Response to problem on hold email dated on 12/6/06 and 12/12/06 for Cleveland Medical Devices Inc.

FCC ID: N9Y0086
Timco Job Number: 2681BUT6

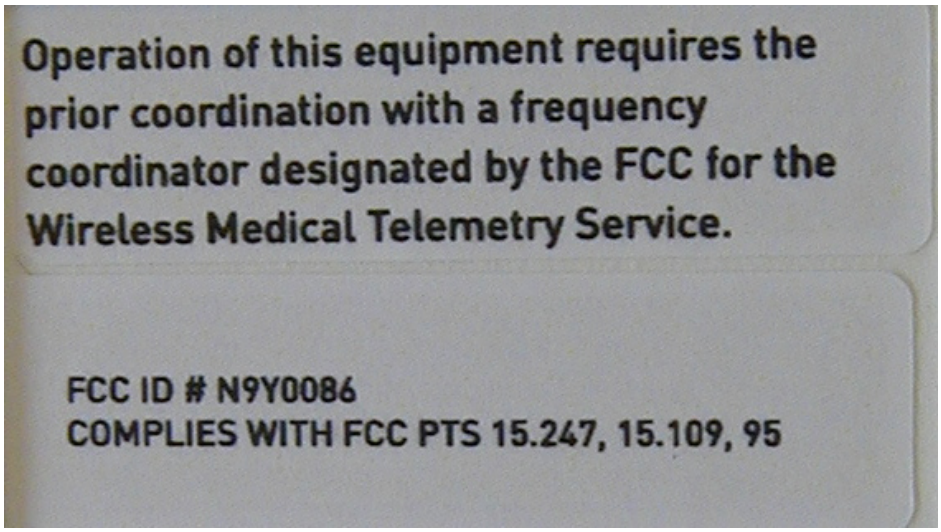
7. Labeling requirement - 95.1109: It requires that each device shall be labeled with the following statement: "Operation of this equipment requires the prior coordination with a frequency coordinator designated by the FCC for the Wireless Medical Telemetry Service".

Response: Page 11 of the users manual does show pictures of the device with these statements and we have included pictures with enhanced view ability in the following page
